Cross Timbers Operating Company

SUNDRY NOTICES AND REPORTS ON WELLS

Federal E #1E

Cross Timbers Operating has already filed the APD for the above mentioned well. The APD is currently in the process of being approved. The original location of the wellsite was in an area of ecological disturbance. The wellsite has now been moved and the plats have been corrected to show the new location.

WELL LOCATION AND ACREAGE DEDICATION PLAT

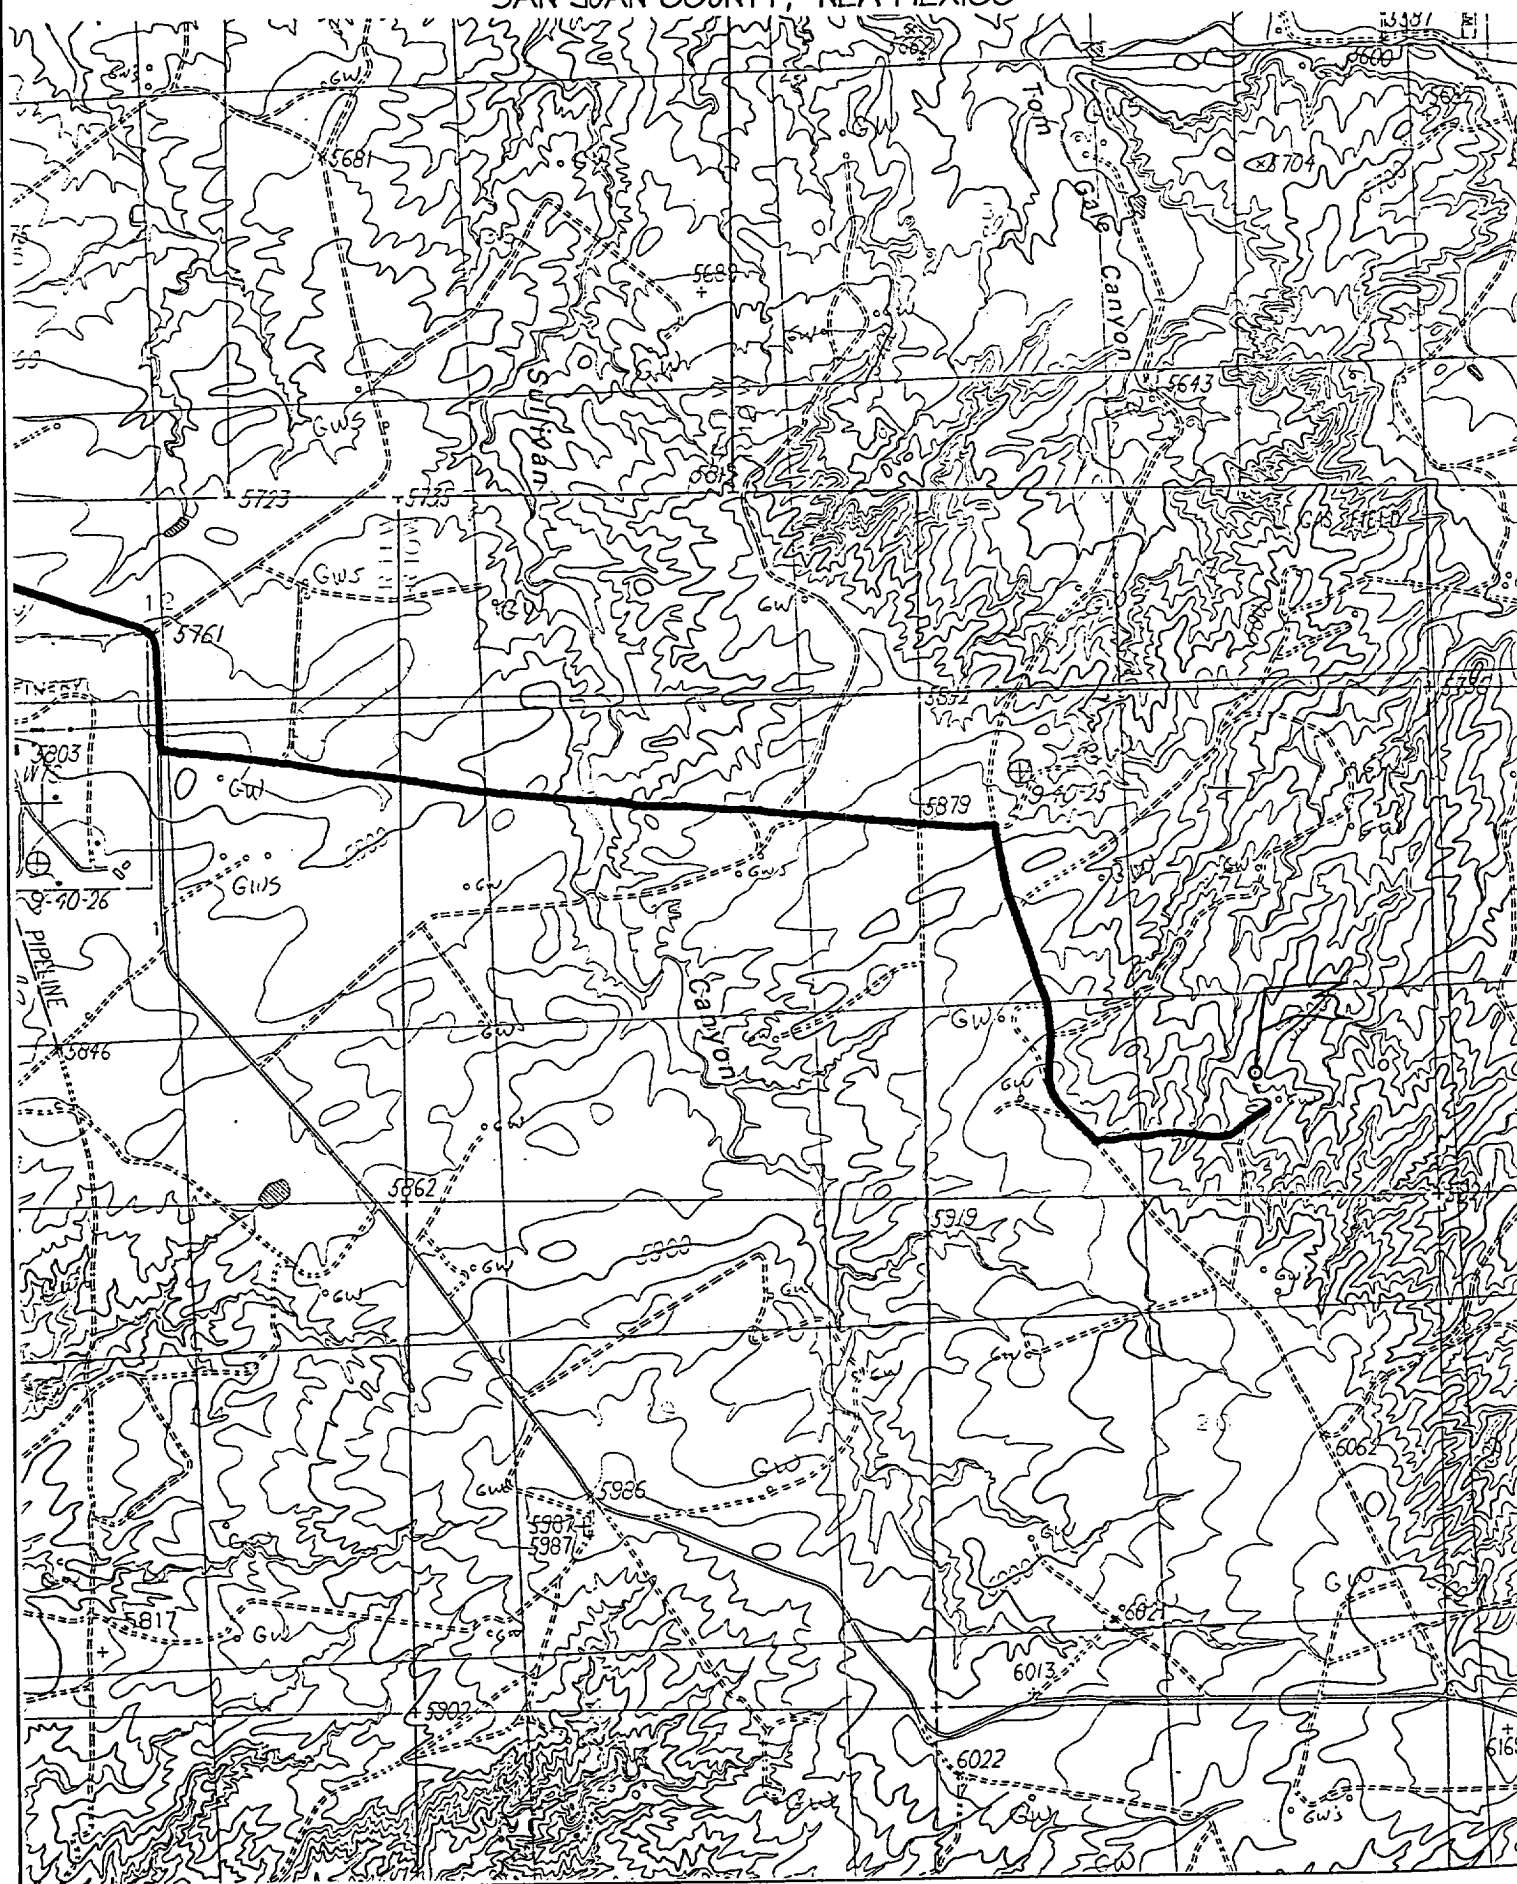
A copy of the new plats are enclosed for your review. Please attach these plats to the APD.

Original Location 1,255' FSL & 930' FEL in Sec 17, T28N, R10W

New Location 1,285' FSL & 1900' FEL in Sec 17, T28N, R10W

UL or lot no.	Section	Township	Range	Lot Idn	Feet from the	North/South line	Feet from the	East/West line	County
0	17	28N	10W		1285	SOUTH	1900	EAST	SAN JUAN
